Date: July 26, 2024

Project Description: Fisher's Technology Multiuse Building

Project/File:	Fisher Tech Multiuse Building / GC24-0015 / DSRFY2024-0013
	This is a design review application to allow for the construction of a new 89,000-square-foot multiuse building designed to complement Fisher's Technology's existing office.
Lead Agency:	Garden City
Site address:	575 E 42 nd Street Garden City, ID 83714
Staff Approval:	July 26, 2024
Applicant:	Jeff Hatch Hatch Design Architecture 200 W 36 th Street Garden City, ID 83714
Owner:	Chris Taylor TSJ LLC 575 E 42 nd Street Garden City, ID 83714
Staff Contact:	Sam Standal Phone: 208-387-6384 E-mail: sstandal@achdidaho.org

C. Site Plan

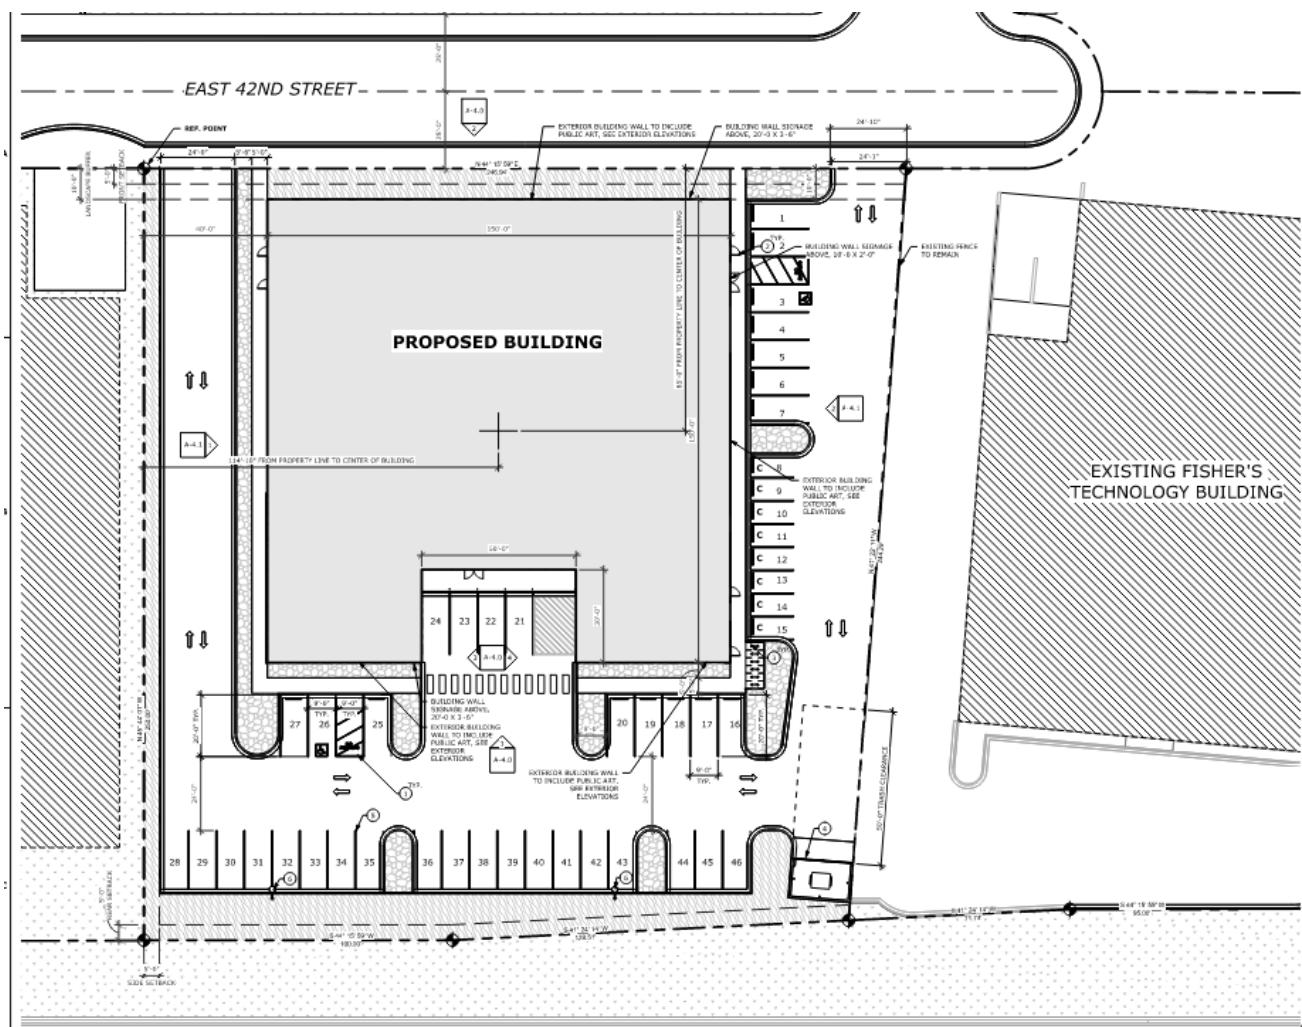
b. Applicant's Proposal: The applicant is proposing to construct two 24-foot-wide paved curb-cut style driveways and to close existing driveway 3, providing access to the southern partition of the site. The applicant has proposed to close the existing driveway with vertical curb, gutter, and 5-foot wide concrete sidewalk to match the improvements on either side. The new driveways are proposed to be constructed as follows:

- New Driveway 1- The applicant is proposing to construct a 24-foot-wide curb-cut type driveway located 18-feet north of the south property line.
- New Driveway 2- The applicant is proposing to construct a 24-foot-wide curb-cut type driveway located 233-feet north of the south property line

1. Repair or replace any broken or deteriorated transportation facilities on 42nd Street and Veterans Memorial Parkway abutting the site.
2. Construct a 24-foot-wide paved curb-cut type driveway located 18-feet north of the south property line, as proposed.

3. Construct a 24-foot-wide paved curb-cut type driveway located 233-feet north of the south property line, as proposed.
4. Close the existing driveway located 109-feet north of the south property line with vertical curb, gutter, and 5-foot-wide concrete sidewalk abutting the site, as proposed.

c. Staff Comments/Recommendations: The applicant's proposal meets all District requirements and should be approved as proposed.
